REPLACED DOORS

D10  
R13 Billiard Room

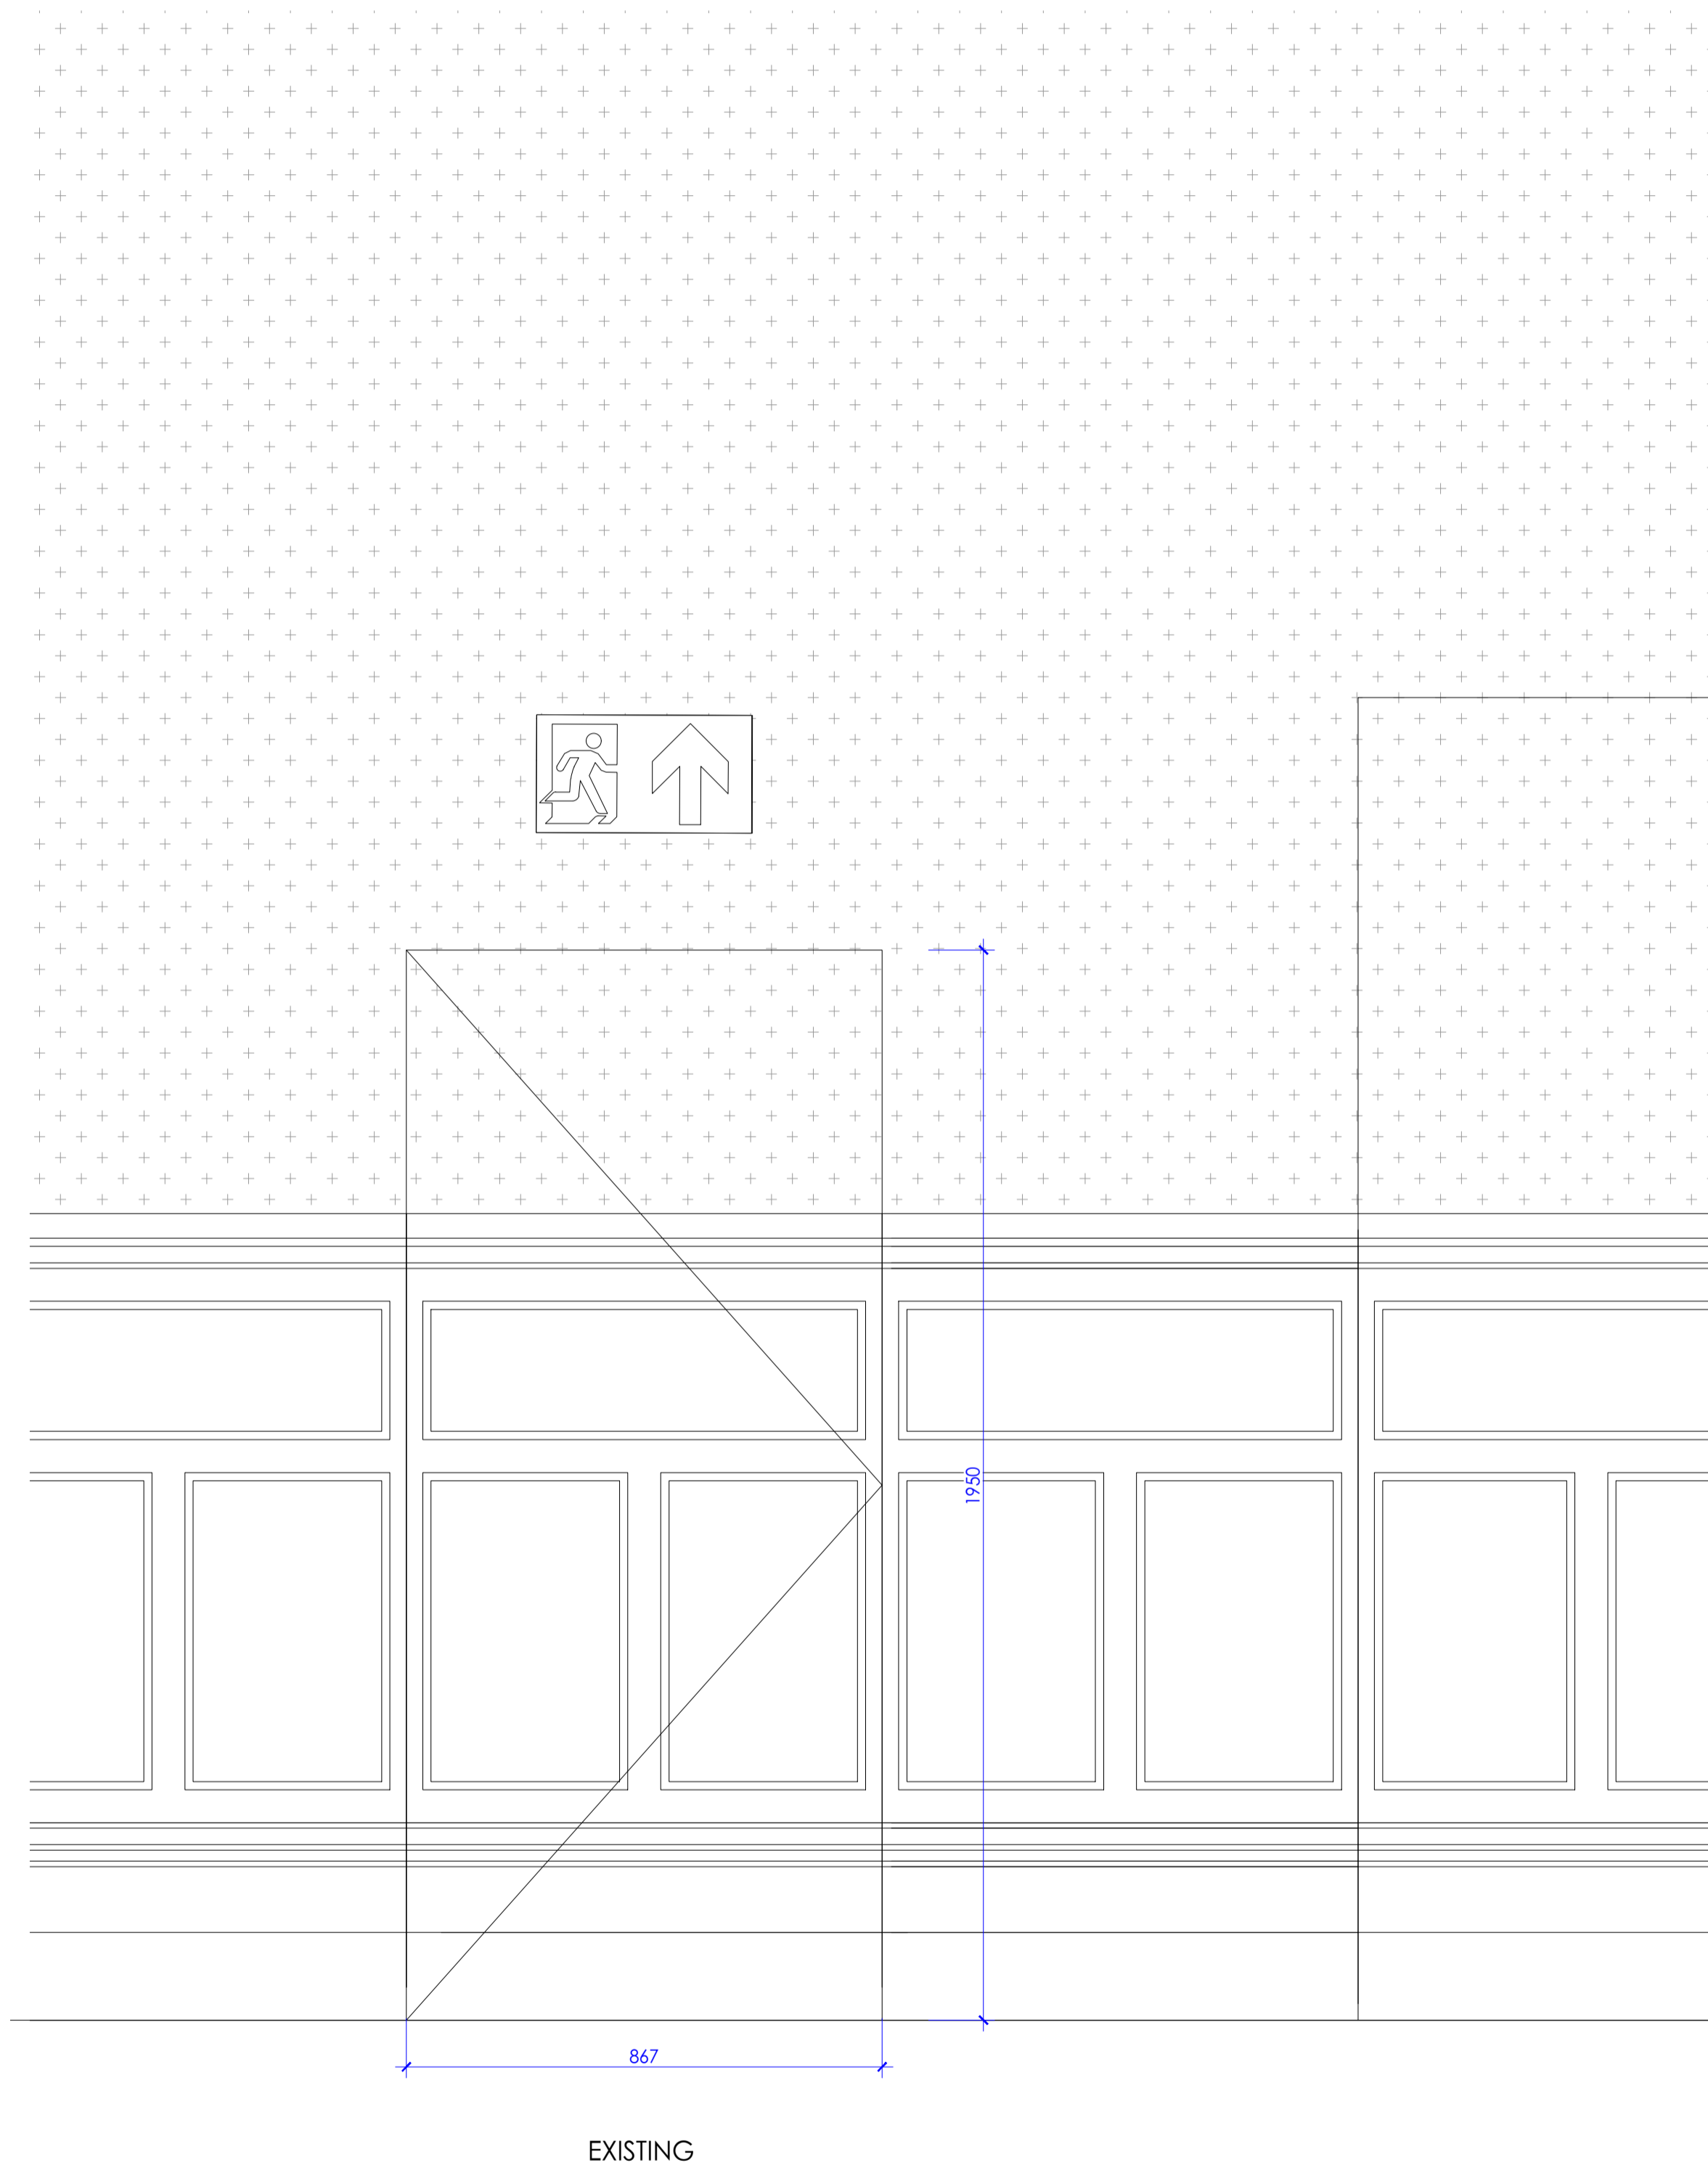
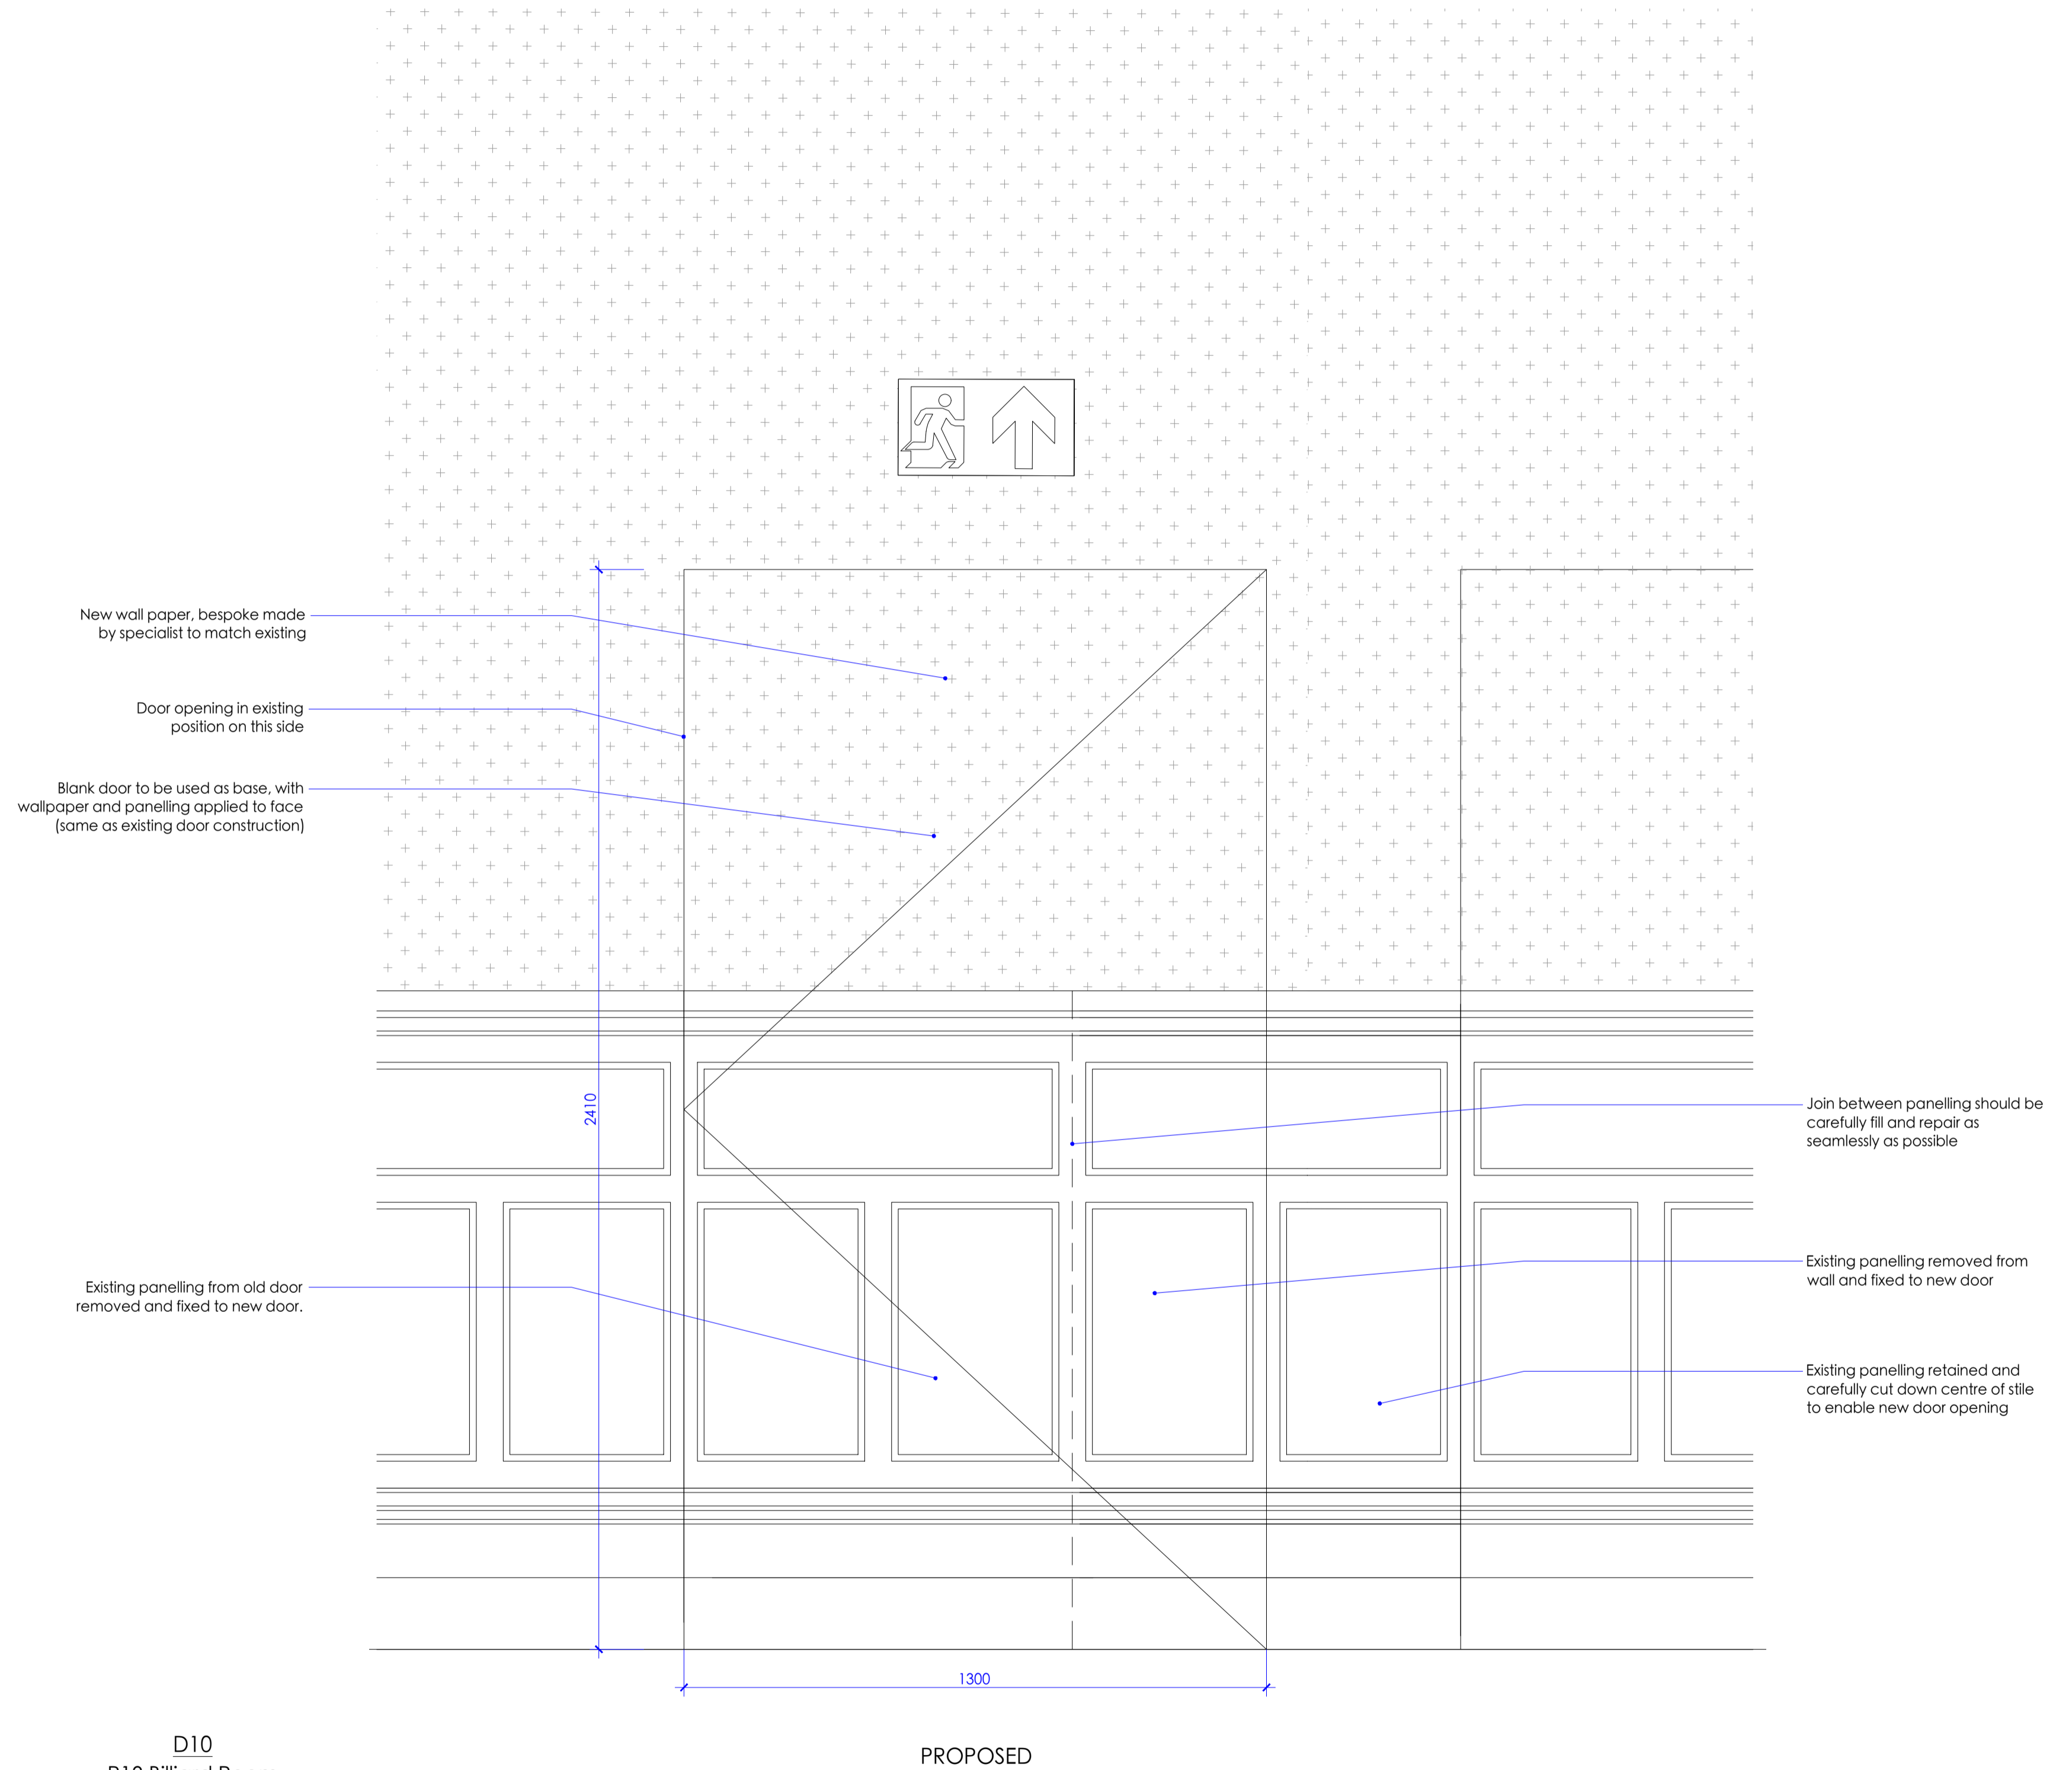
Jib door recreated with larger opening. Height dimension of the new door to be aligned with the adjacent existing folding panels. Width of the new door to be aligned with the central line of the existing modular panels. Dimensions to be checked on site. Pull handle at the lobby side. Antique brass finish
